City of Grain Valley, Missouri
TAP 3456(402) SW Eagles Parkway (Rte. AA) – Phase A
September 9, 2026
Addendum No. 2

1. Delete the following Drawings in their entirety: Sheet 4. Replace with the following drawings attached to this Addendum No. 2: Sheet 4.
 - a. Sheet 4 – added bid items.

DISTRICT	SHEET NO.
	4

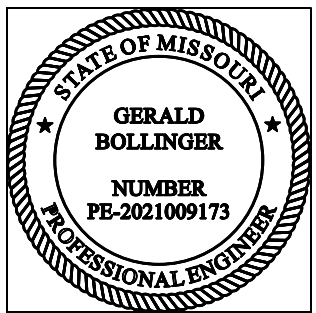
1. Item No. 11 – Rock Lining 800 cy. We can only find 3 areas where Rock Lining is called out for in the plans. The total volume for these three areas is 49 cy. Can you verify that the planned contract amount is correct?

1. Bid Form Article 5 – Basis of Bid
 1. Delete the pages with Article 5 – Basis of Bid to Article 8 – Bid Submittal and replace with the attached version.
 2. The total rock lining quantity revised to 50 CY.
2. Bid Bond
 1. Delete the Bid Bond and replace with the attached version.
 2. Project name was revised.

- a. The 800 CY of rock lining will be revised to 50 CY of rock lining. The Bid Book pages and drawing pages will be updated with Addendum 2.
2. Will the temporary traffic signal trailers be operated 24 hours a day during construction, or will they be required to be removed as construction activities stop each day / night?
